TPA-CN- 0820

TPA CHANGE NOTICE FORM

DOE/RL-2014-42, Rev. 0, 300-FF-5 Operable Unit Remedy Implementation Sampling and Analysis Plan, Rev. 0

Figure 3-5. Groundwater Sampling Network for Uranium at the 618-10 Burial Ground/316-4 Crib

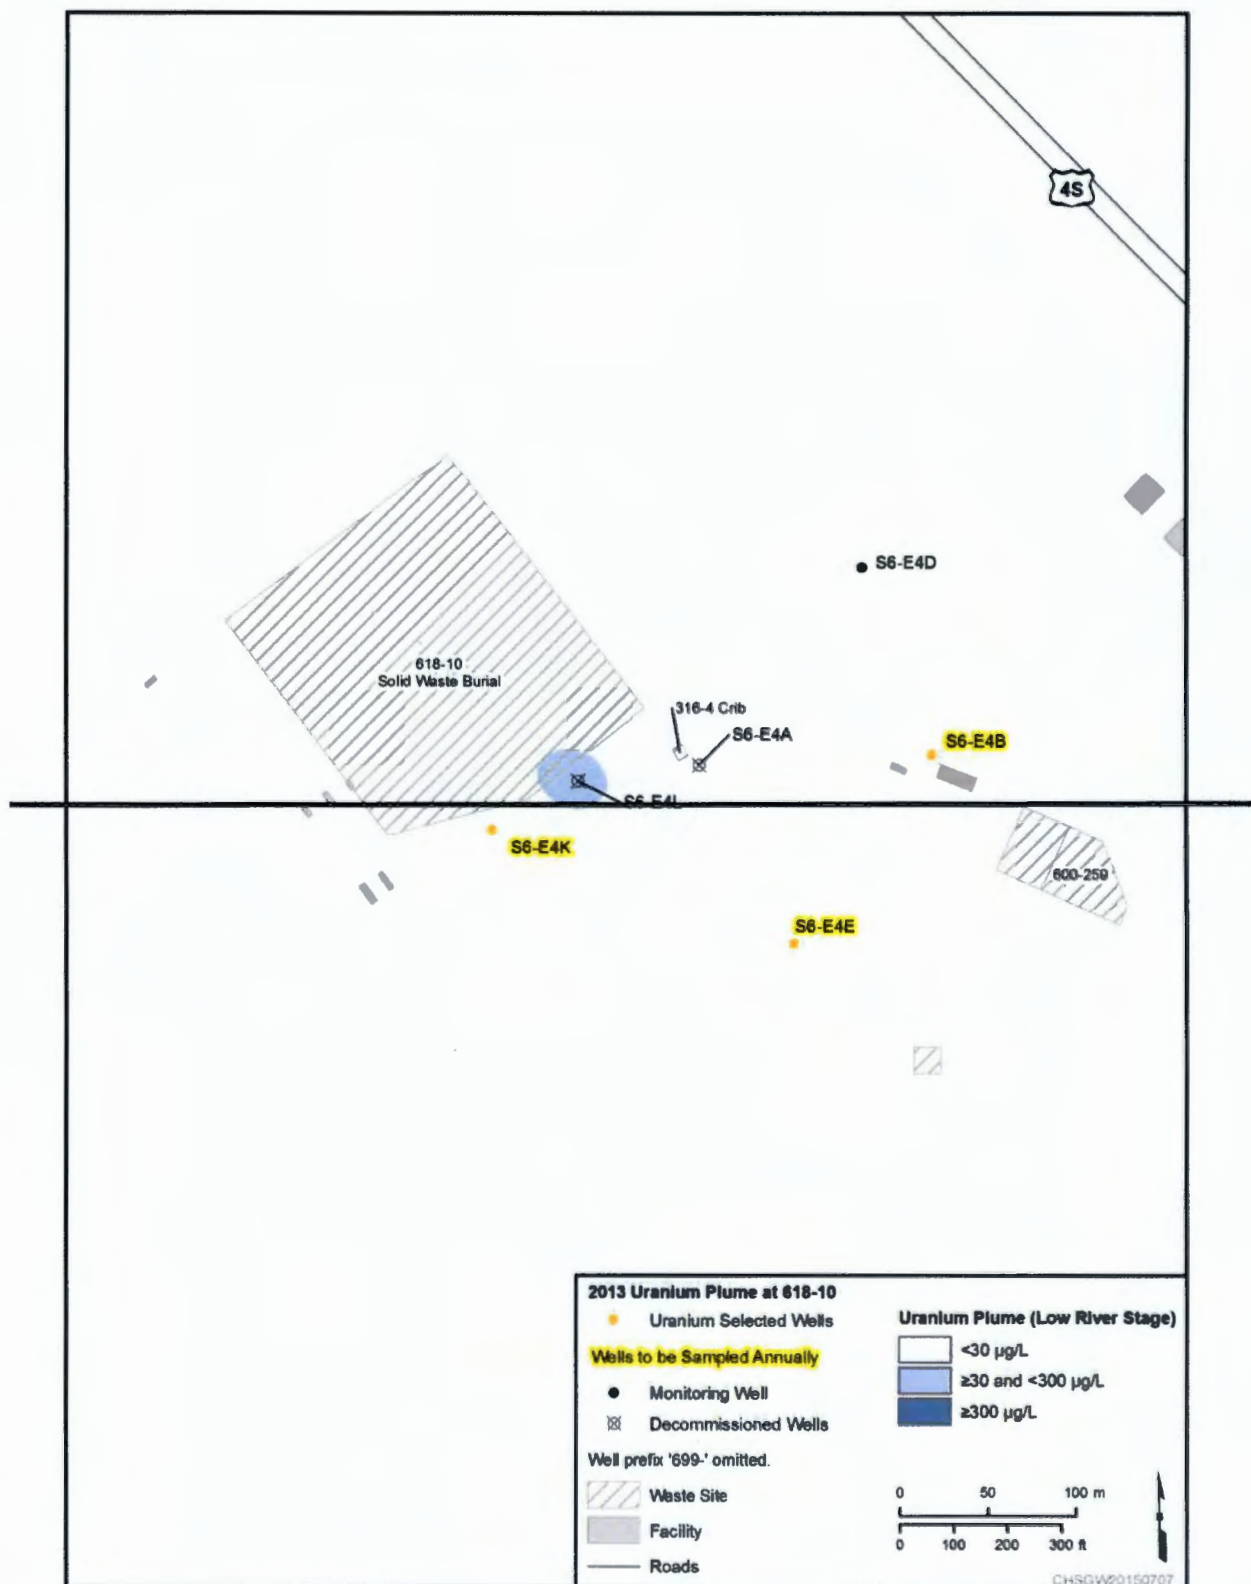
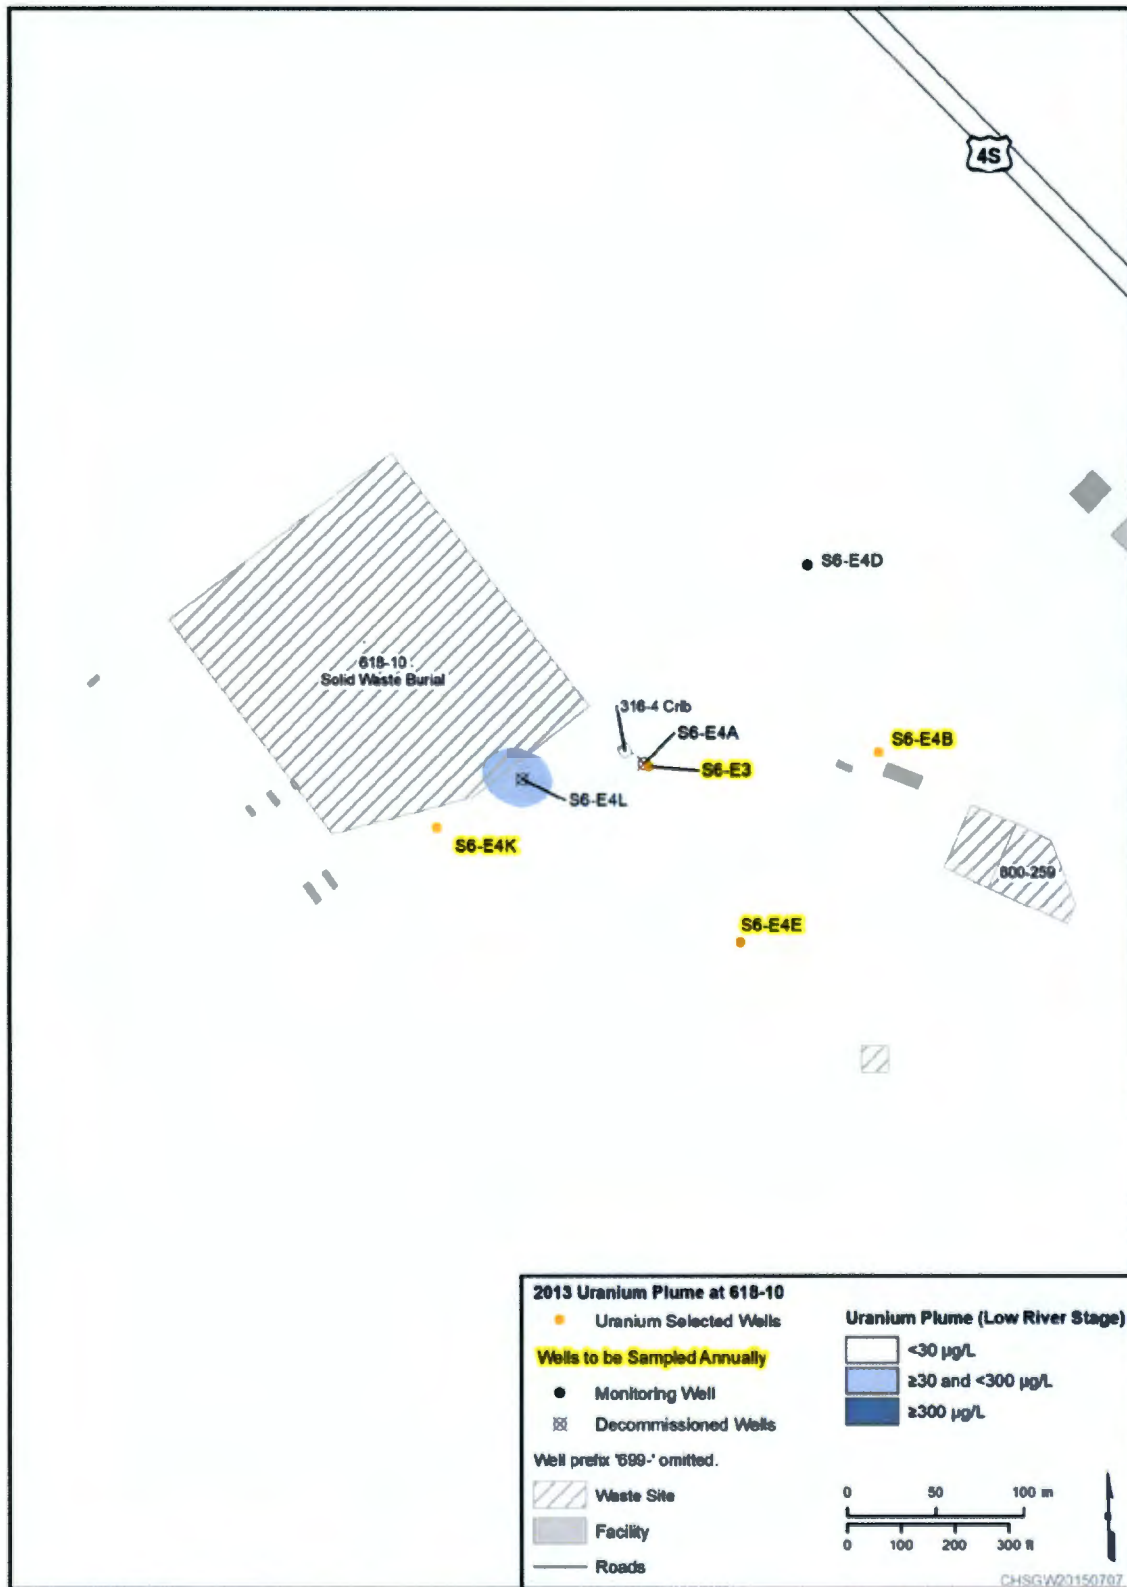
One new groundwater well is added to the remedy implementation sampling and analysis plan for the 300-FF-5 Operable Unit, DOE/RL-2014-42, Rev. 0. The well was installed as a replacement groundwater monitoring well at the former 316-4 Crib. Minor correction is also made to Table 3-6 to correct a well name.

Additions are shown using double underline. Deletions are shown using ~~strikeout~~. Figure 3-5 is replaced with a new figure as indicated by strikeout on old figure.

Groundwater well 699-S6-E3 (C9870) was drilled as a replacement groundwater monitoring well at the former 316-4 Crib. The sampling and analysis plan is modified to add this well to the 300-FF-5 Operable Unit long-term groundwater monitoring network.
